Wednesday, June 3, 2026
Planning Commission

A. CONSTRUCTION STANDARDS REVISION (26.01). This proposal involves various updates being made to the City's Construction Standards.

Construction Standard Drawings

(801) 804-4550
STANDARD DRAWING
2" WATER SERVICE
DRAWN: JLR
DESIGN: MHC
REVISION:
DATE: 7/15/2025
SCALE
NONE
STANDARD
W-216

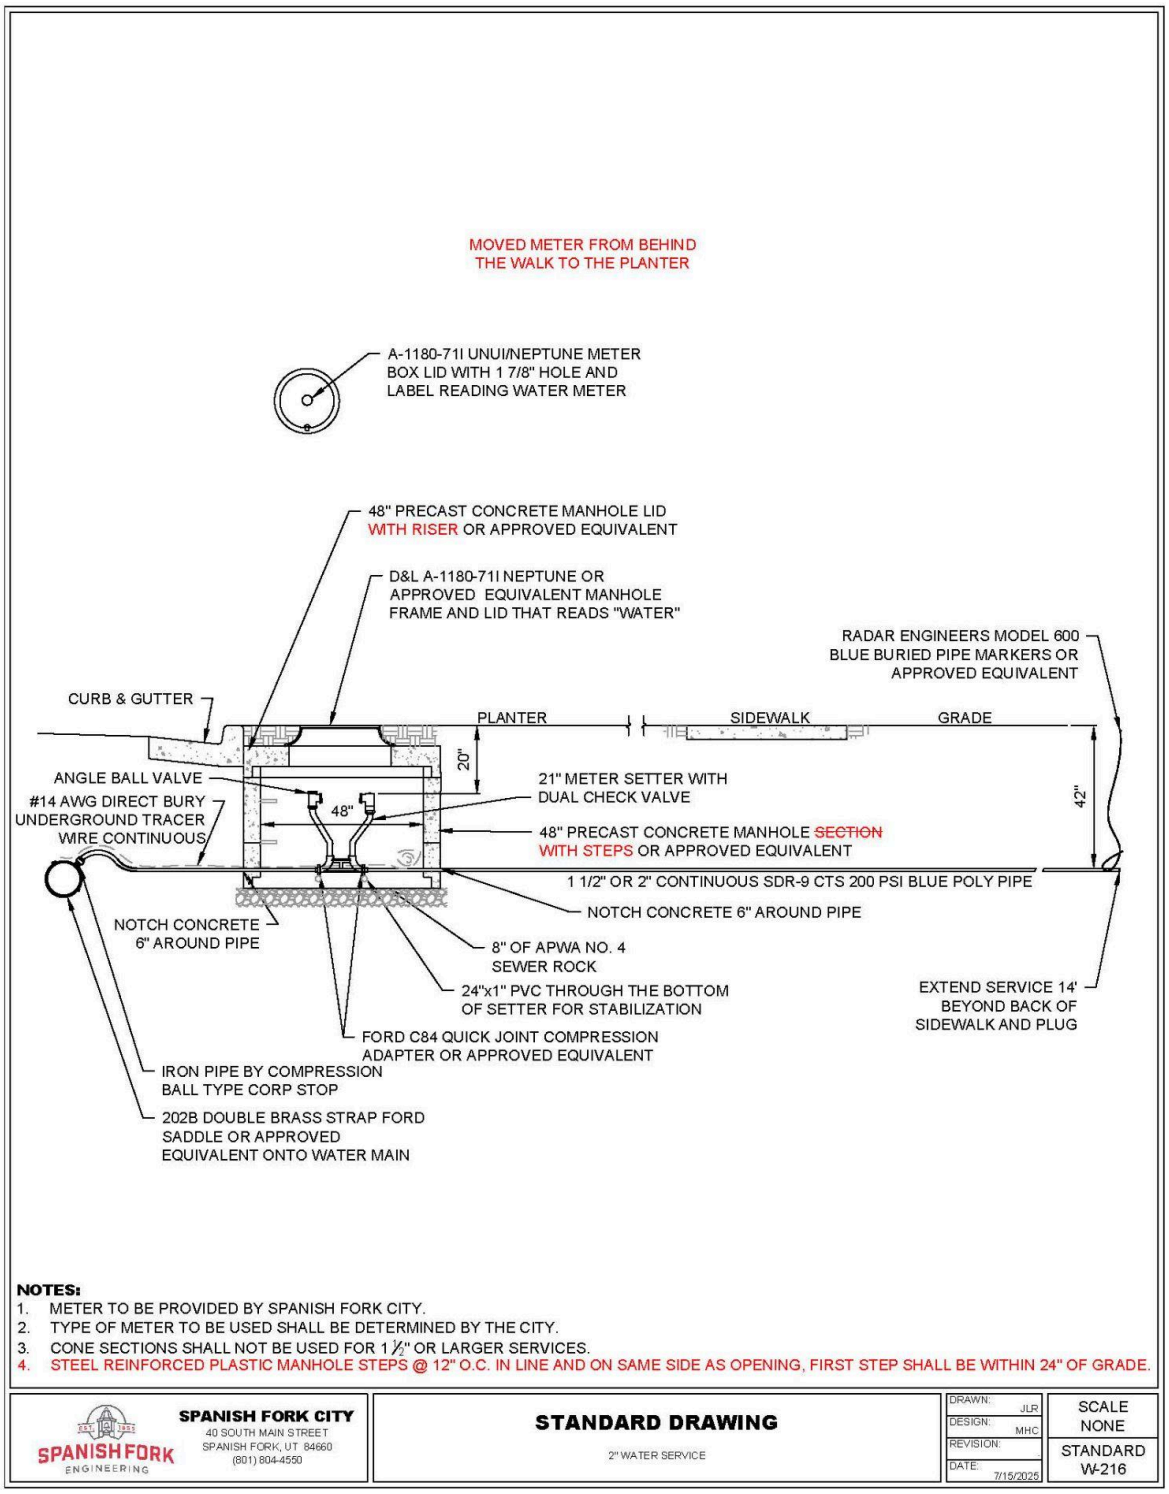
MOVED METER FROM BEHIND
THE WALK TO THE PLANTER
A-1180-71I UNUI/NEPTUNE METER
BOX LID WITH 1 7/8" HOLE AND
LABEL READING WATER METER
48" PRECAST CONCRETE MANHOLE LID
WITH RISER OR APPROVED EQUIVALENT
D&L A-1180-71I NEPTUNE OR
APPROVED EQUIVALENT MANHOLE
FRAME AND LID THAT READS "WATER"
RADAR ENGINEERS MODEL 600
BLUE BURIED PIPE MARKERS OR
APPROVED EQUIVALENT
CURB & GUTTER
PLANTER
SIDEWALK
GRADE
20"
42"
ANGLE BALL VALVE

SPANISH FORK ENGINEERING	SPANISH FORK CITY 40 SOUTH MAIN STREET SPANISH FORK, UT 84660 (801) 804-4550	**STANDARD DRAWING** TREE PLANTING	DRAWN: JLR DESIGN: MHC REVISION: DATE: 12/17/2025	SCALE NONE STANDARD G-112

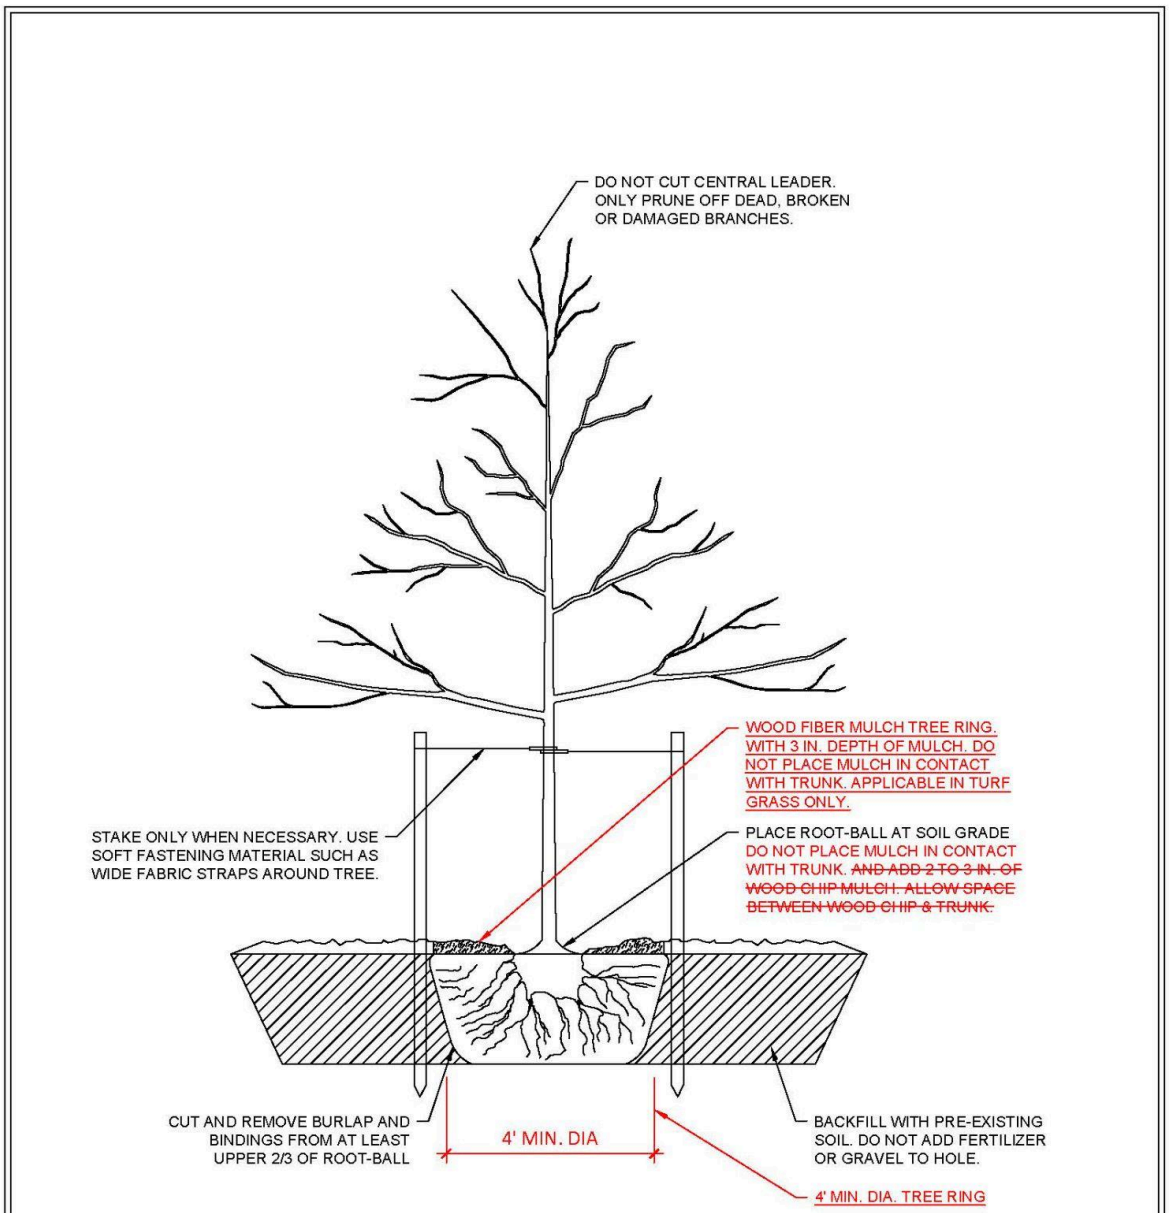
1. WOOD ~~CHIPS~~ AND ROCK MULCH SHALL BE REMOVED FROM DIRECTLY TOUCHING TRUNK.
2. DEPTH OF HOLE SHOULD BE NO DEEPER THAN THE ROOT-BALL.
3. DIAMETER OF HOLE SHOULD BE THREE TIMES THAT OF THE ROOT-BALL.
4. WOOD FIBER MULCH TREE RINGS ARE ONLY REQUIRED IN TURF GRASS AREAS.

SPANISH FORK CITY 40 SOUTH MAIN STREET SPANISH FORK, UT 84660 (801) 804-4550	**STANDARD DRAWING** RESIDENTIAL UNDERGROUND SERVICE 200 AMPS OR LESS	DRAWN: TC DESIGN: TC REVISION: KT DATE: 3/12/2026	SCALE NONE STANDARD E-602

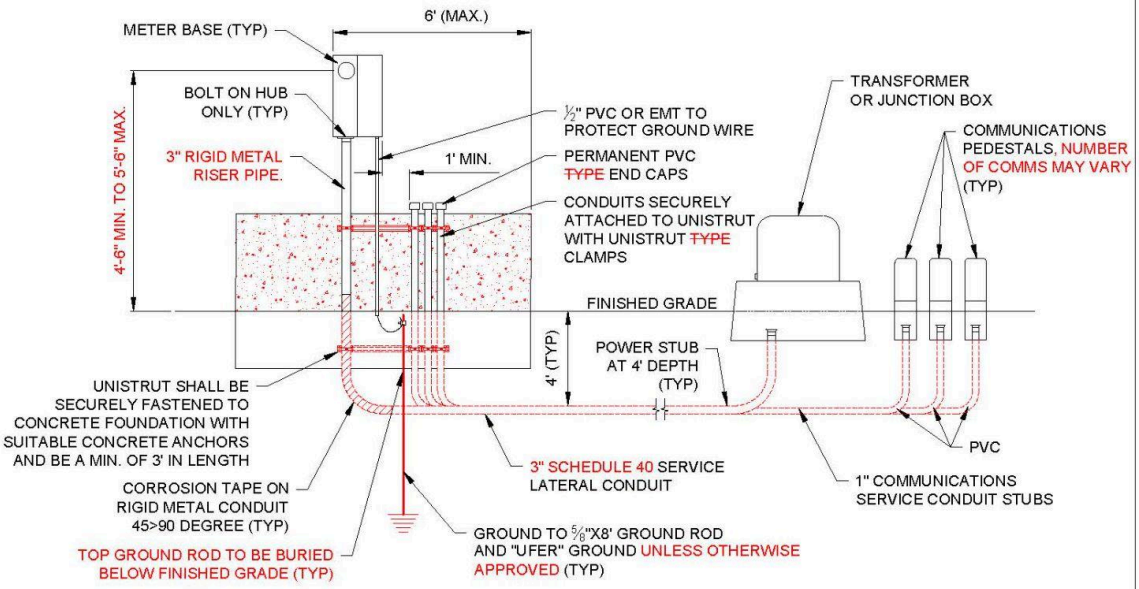
SERVICE SIZE	NEC WIRE SIZE	CONDUIT SIZE
100 AMP	#2 ALU	~~2"~~3"
125 AMP	1/0 ALU	~~2"~~3"
150 AMP	2/0 ALU	~~2"~~3"
200 AMP	4/0 ALU	~~2"~~3"
201 AMPS-~~400~~800 AMPS SEE ELECTRICAL DIVISION

SPANISH FORK CITY 40 SOUTH MAIN STREET SPANISH FORK, UT 84660 (801) 804-4550	**STANDARD DRAWING** SECONDARY JUNCTION PEDESTAL	DRAWN: TC DESIGN: TC REVISION: KT DATE: 3/12/2026	SCALE NONE STANDARD E-605

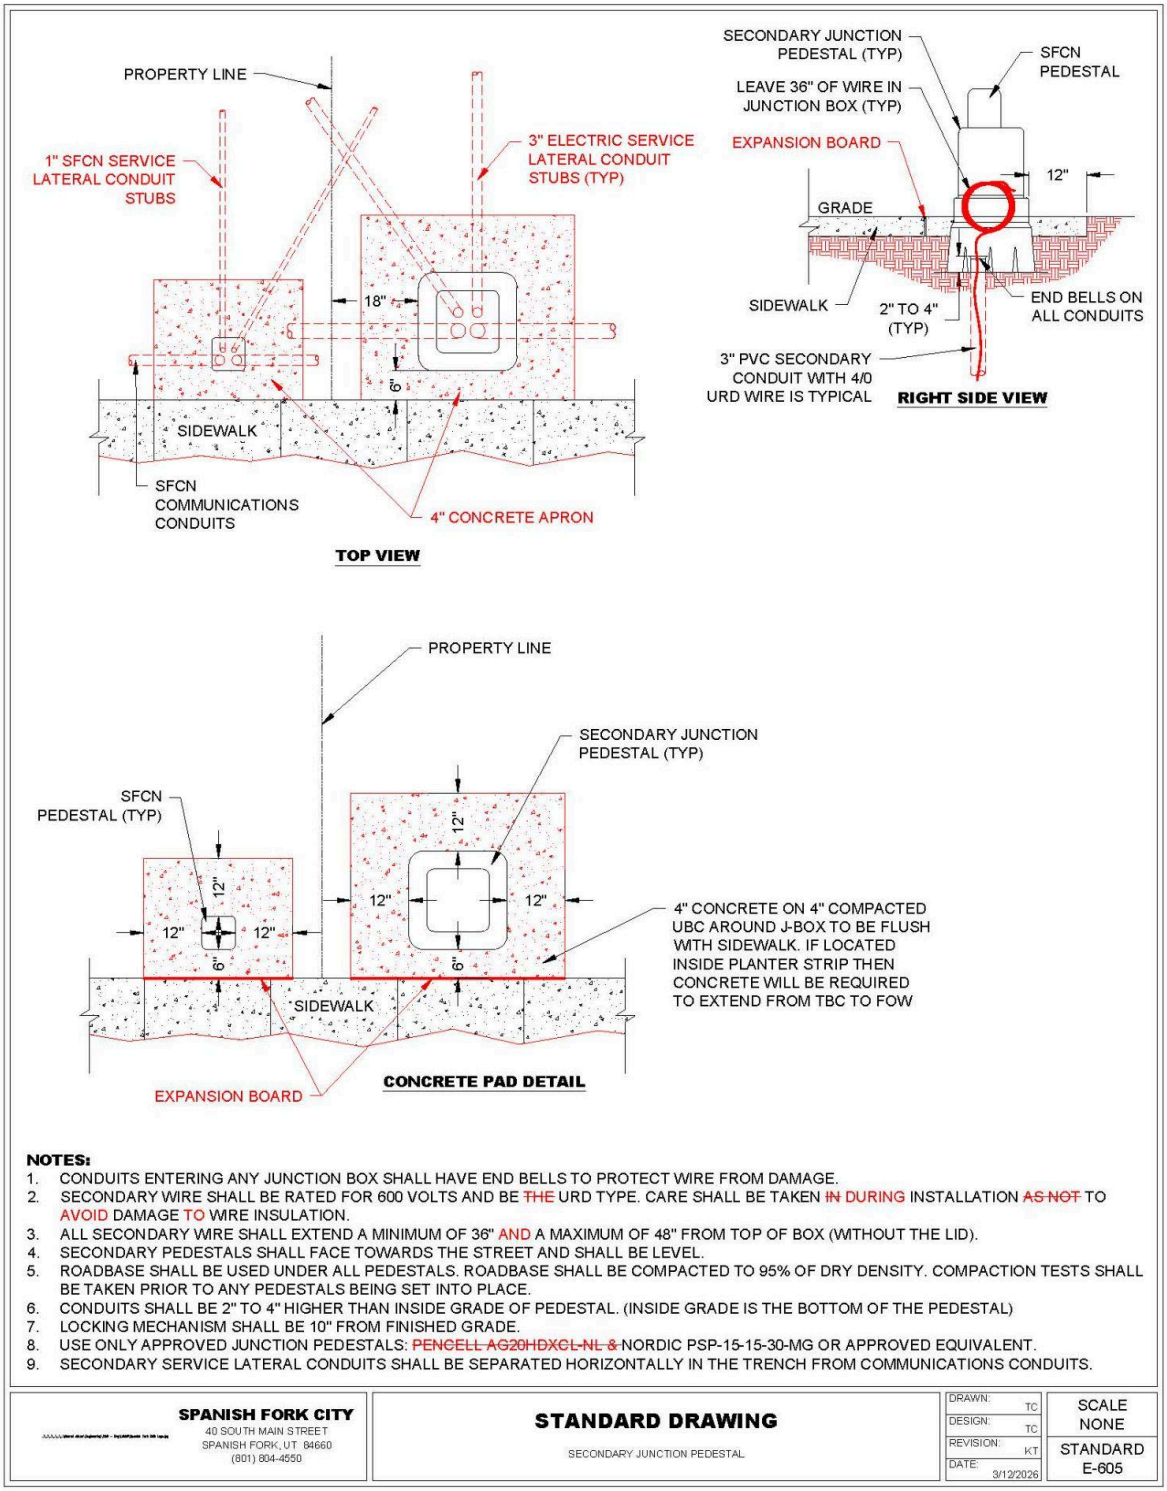
1. CONDUITS ENTERING ANY JUNCTION BOX SHALL HAVE END BELLS TO PROTECT WIRE FROM DAMAGE.
2. SECONDARY WIRE SHALL BE RATED FOR 600 VOLTS AND BE ~~THE~~ URD TYPE. CARE SHALL BE TAKEN ~~IN~~ DURING INSTALLATION ~~AS NOT~~ TO AVOID DAMAGE TO WIRE INSULATION.

SPANISH FORK CITY 40 SOUTH MAIN STREET SPANISH FORK, UT 84660 (801) 804-4550	**STANDARD DRAWING** 200-AMP 1 AND 3 PHASE FIBERGLASS SECTIONALIZER	DRAWN: JLR DESIGN: MHC REVISION: KT DATE: 3/12/2026	SCALE NONE STANDARD E-608

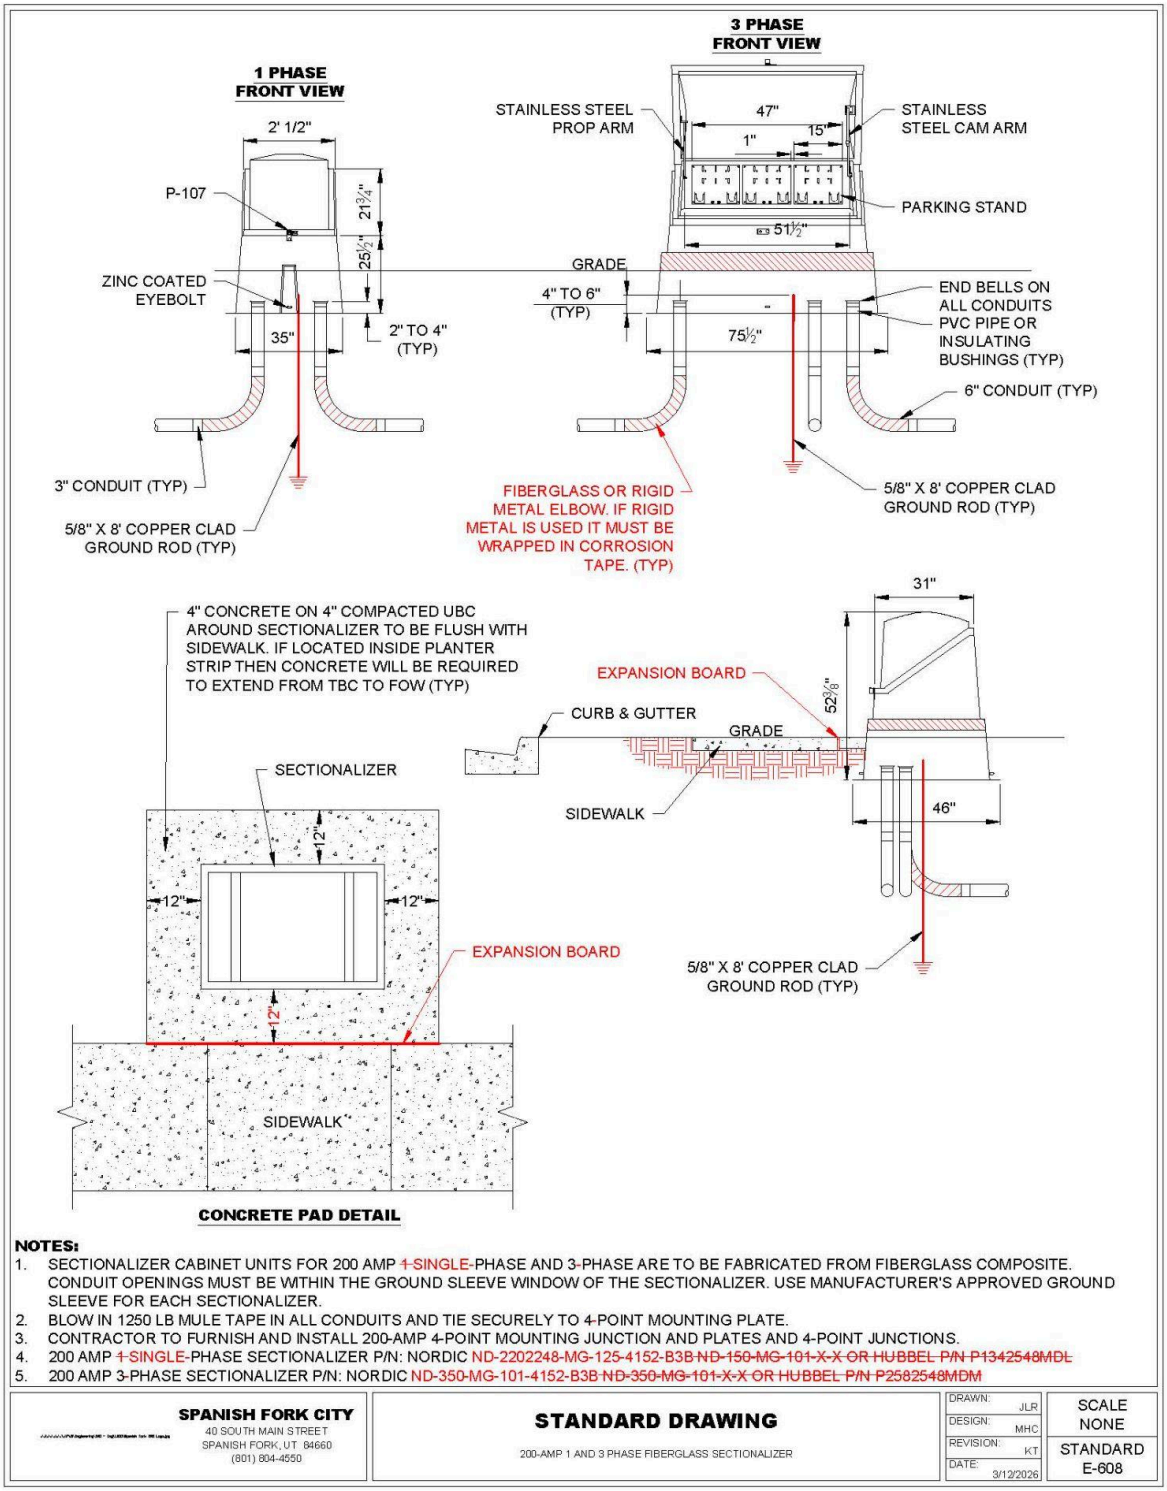
1. SECTIONALIZER CABINET UNITS FOR 200 AMP ~~1-~~SINGLE-PHASE AND 3-PHASE ARE TO BE FABRICATED FROM FIBERGLASS COMPOSITE. CONDUIT OPENINGS MUST BE WITHIN THE GROUND SLEEVE WINDOW OF THE SECTIONALIZER. USE MANUFACTURER'S APPROVED GROUND SLEEVE FOR EACH SECTIONALIZER.
2. BLOW IN 1250 LB MULE TAPE IN ALL CONDUITS AND TIE SECURELY TO ~~4-~~POINT MOUNTING PLATE.
3. CONTRACTOR TO FURNISH AND INSTALL 200-AMP 4-POINT MOUNTING JUNCTION AND PLATES AND 4-POINT JUNCTIONS.
4. 200 AMP ~~1-SINGLE-~~PHASE SECTIONALIZER P/N: NORDIC ND-2202248-MG-125-4152-B3B ~~ND-150-MG-101-X-X OR HUBBEL P/N P1342548MDL~~
5. 200 AMP 3-PHASE SECTIONALIZER P/N: NORDIC ND-350-MG-101-4152-B3B ~~ND-350-MG-101-X-X OR HUBBEL P/N P2582548MDM~~

SPANISH FORK CITY 40 SOUTH MAIN STREET SPANISH FORK, UT 84660 (801) 804-4550	**STANDARD DRAWING** CONDUIT ROUTING	DRAWN: JLR DESIGN: MHC REVISION: KT DATE: 3/12/2026	SCALE NONE STANDARD E-611

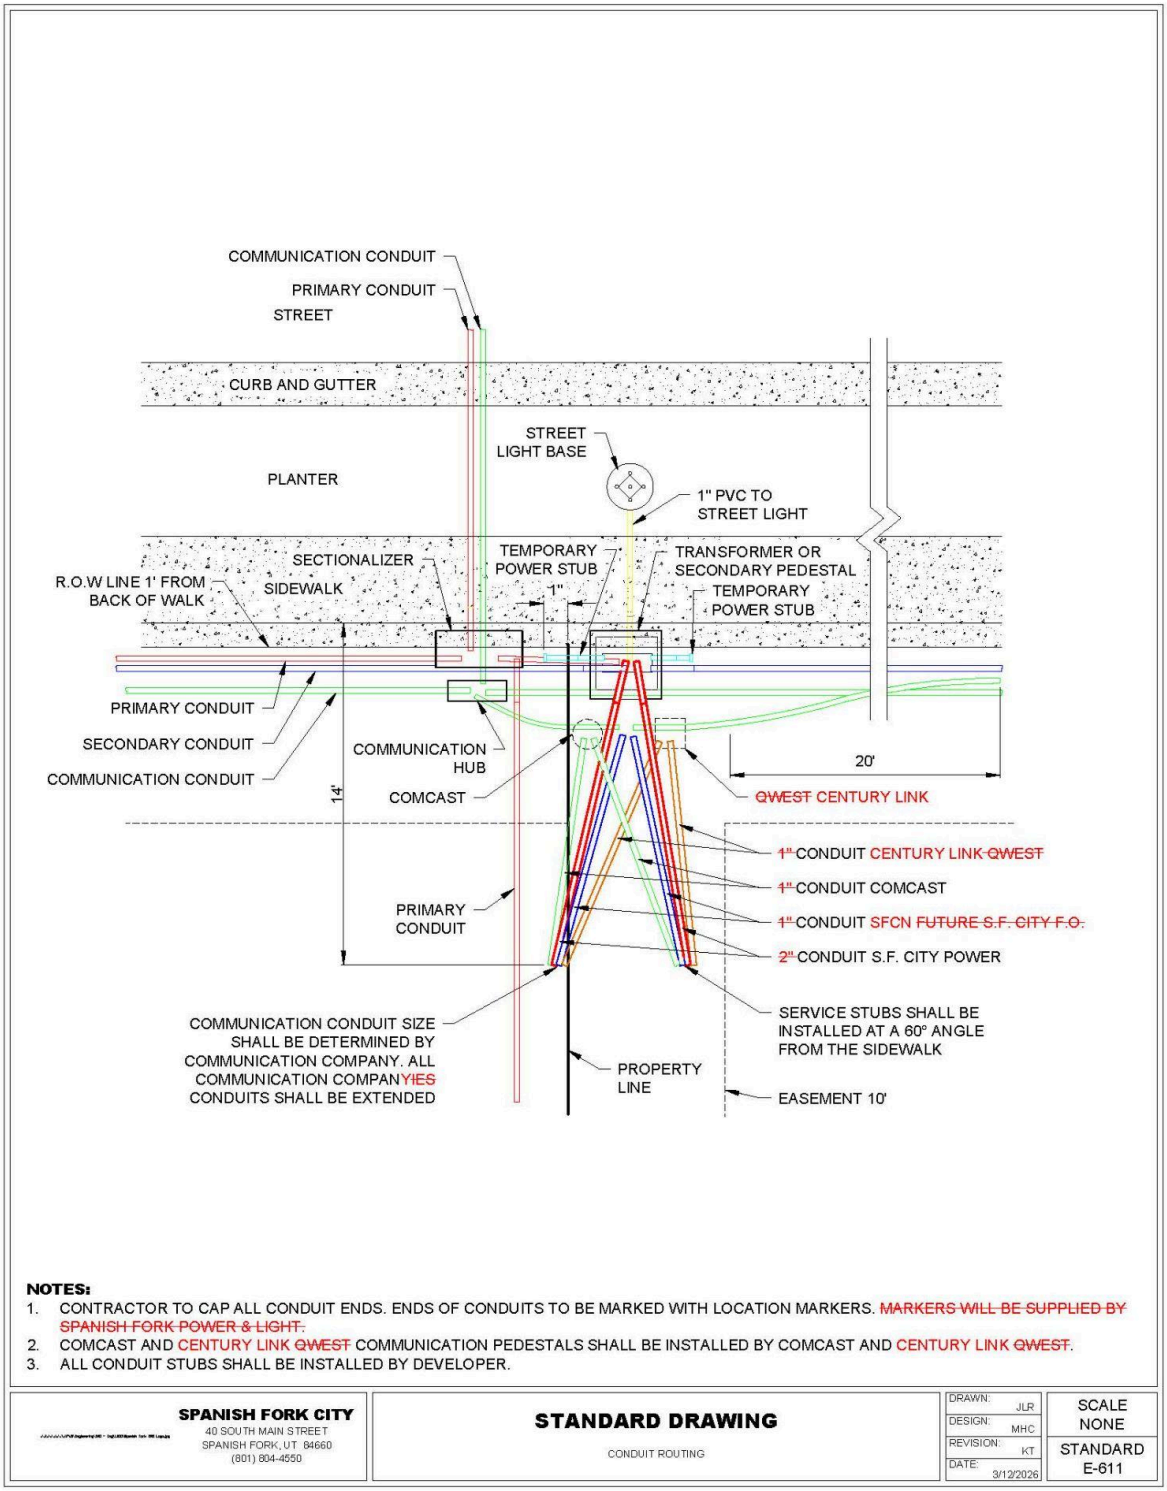
1. CONTRACTOR TO CAP ALL CONDUIT ENDS. ENDS OF CONDUITS TO BE MARKED WITH LOCATION MARKERS. ~~MARKERS WILL BE SUPPLIED BY SPANISH FORK POWER & LIGHT.~~
2. COMCAST AND CENTURY LINK ~~QWEST~~ COMMUNICATION PEDESTALS SHALL BE INSTALLED BY COMCAST AND CENTURY LINK ~~QWEST~~.
3. ALL CONDUIT STUBS SHALL BE INSTALLED BY DEVELOPER.

SPANISH FORK CITY 40 SOUTH MAIN STREET SPANISH FORK, UT 84660 (801) 804-4550	**STANDARD DRAWING** 600 AMP PSE 9/11 SWITCHGEAR	DRAWN: TC DESIGN: TC REVISION: KT DATE: 3/12/2026	SCALE NONE STANDARD E-613

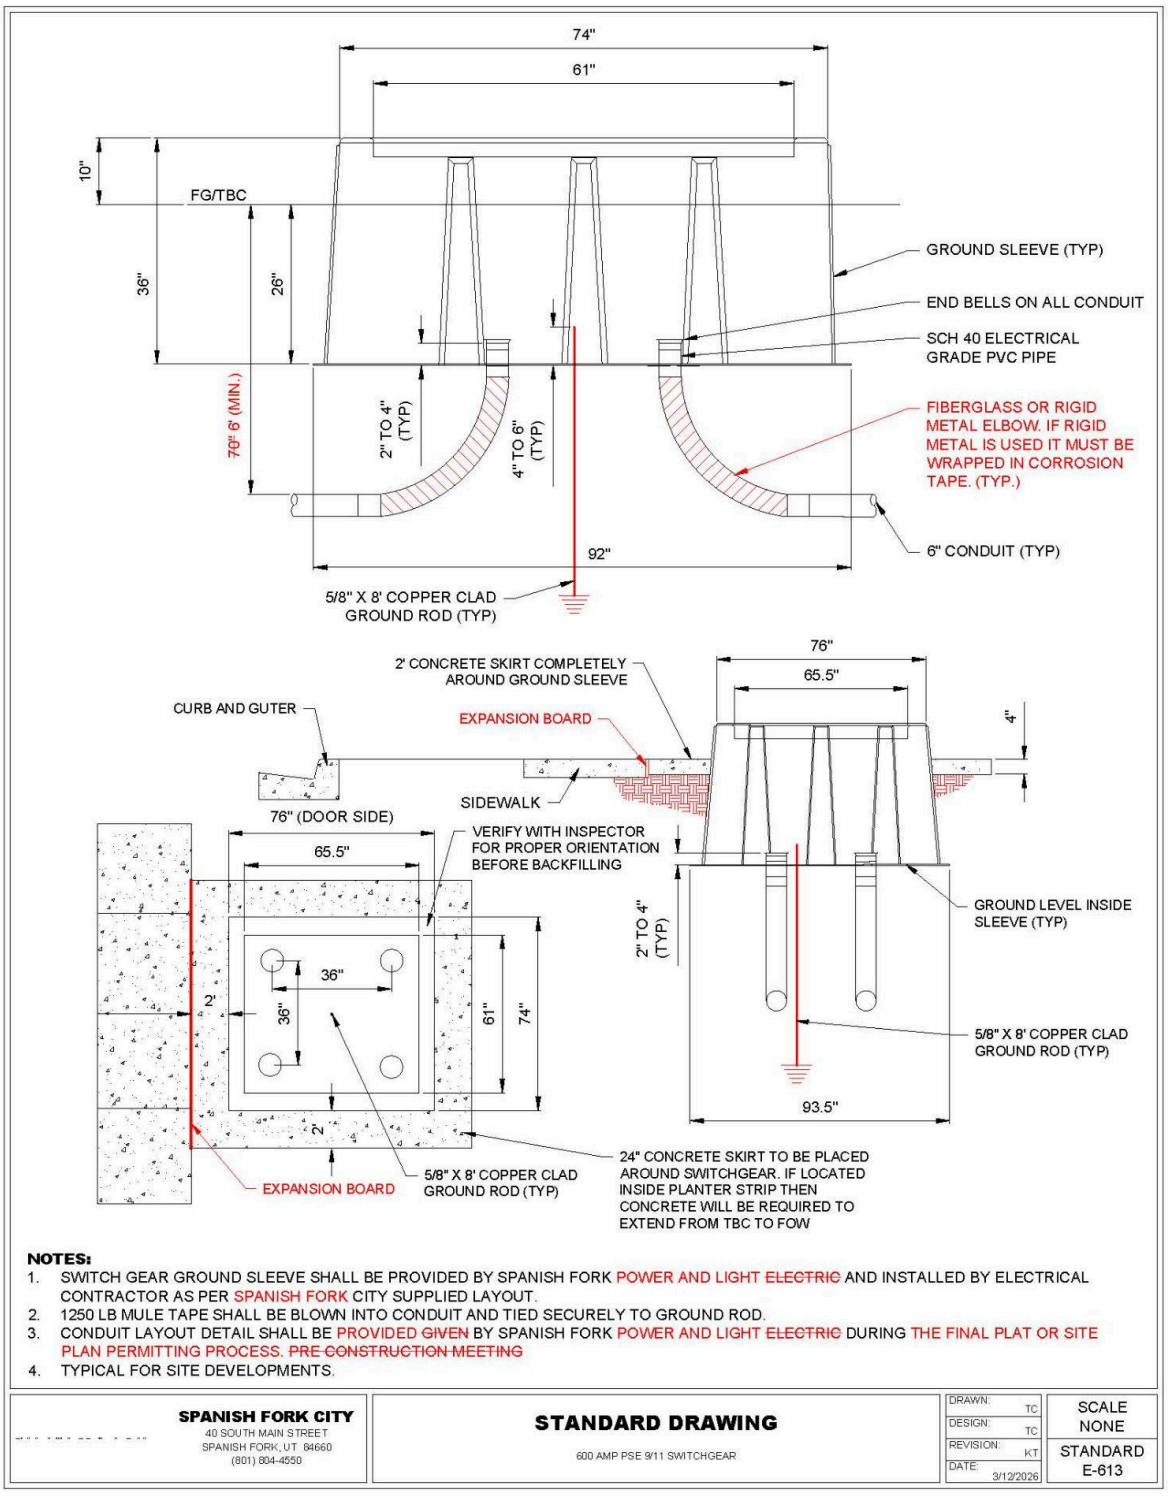
1. SWITCH GEAR GROUND SLEEVE SHALL BE PROVIDED BY SPANISH FORK POWER AND LIGHT ~~ELECTRIC~~ AND INSTALLED BY ELECTRICAL CONTRACTOR AS PER SPANISH FORK CITY SUPPLIED LAYOUT.
2. 1250 LB MULE TAPE SHALL BE BLOWN INTO CONDUIT AND TIED SECURELY TO GROUND ROD.
3. CONDUIT LAYOUT DETAIL SHALL BE PROVIDED ~~GIVEN~~ BY SPANISH FORK POWER AND LIGHT ~~ELECTRIC~~ DURING THE FINAL PLAT OR SITE PLAN PERMITTING PROCESS. ~~PRE-CONSTRUCTION MEETING~~
4. TYPICAL FOR SITE DEVELOPMENTS.
